# PowerSpan II™ Device Errata and Design Notes

80A1010\_ER001\_13

November 4, 2009

Figure 1: Logic Required to Delay Deasserting PO\_RST\_ to PowerSpan II

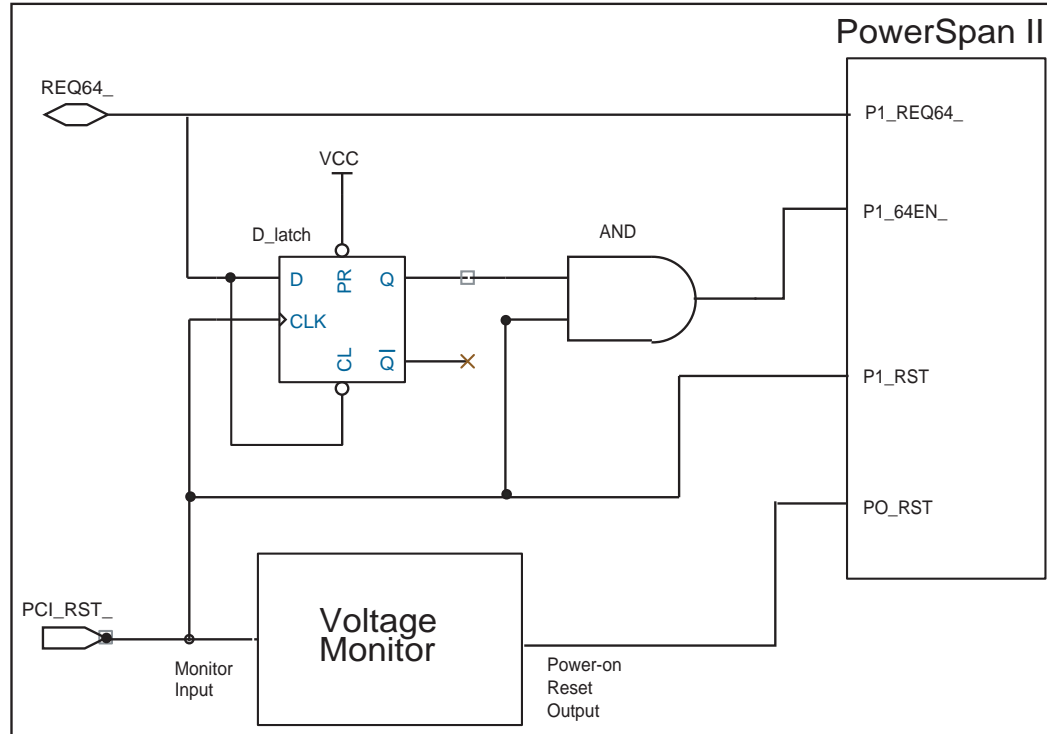
The proposed work-around to this situation is to delay deasserting PO\_RST\_ to PowerSpan II until the host deasserts the PCI\_RST\_ signal. Since the PCI\_CLK is an output from the system controller along with PCI\_RST\_, the negation of PCI\_RST\_ implies the PCI\_CLK is stable. The local voltage monitor uses PCI\_RST\_ to make sure that the PCI\_CLK is stable before the deassertion of PO\_RST\_. A possible implementation of this circuit is shown in [Figure 1](#).

By generating PO\_RST\_ off of PCI\_RST\_, there is a chance that the PowerSpan II will be unable to latch the state of the REQ64\_ signal on deassertion of PCI\_RST\_. Therefore, an external D-Latch is used to capture the state of REQ64\_ to determine the width of the bus (see [Figure 1](#)). The purpose of the asynchronous clear on D-latch is to prevent potential bus contention on the REQ64\_ signal which is driven by PowerSpan II on the deassertion of P1\_RST\_ in a 32-bit system. The P1\_64EN\_ signal, which is originally used for CompactPCI Hot Swap applications, is used here to tell the PowerSpan II if this is a 32 or 64-bit application. The AND gate is AND-ing the output of D-latch with PCI\_RST\_ to ensure the P1\_64EN\_ is low when the D-latch power-up with uncertain output.

If the external glue logic shown in Figure 1 is implemented by a CPLD, make sure the CPLD output and Flip-flop state are not affected by any reset.

This work-around only applies to designs where PowerSpan II is in a PCI adapter card and is configured for a non-Hot Swap environment. Normally in this scenario, the PCI bus width is indicated by P1\_REQ64\_ signal (P1\_64EN\_ is pulled high). For designs where PowerSpan II is in a PCI host card or it is configured for a Hot Swap environment, the circuit shown in Figure 1 must not be used.
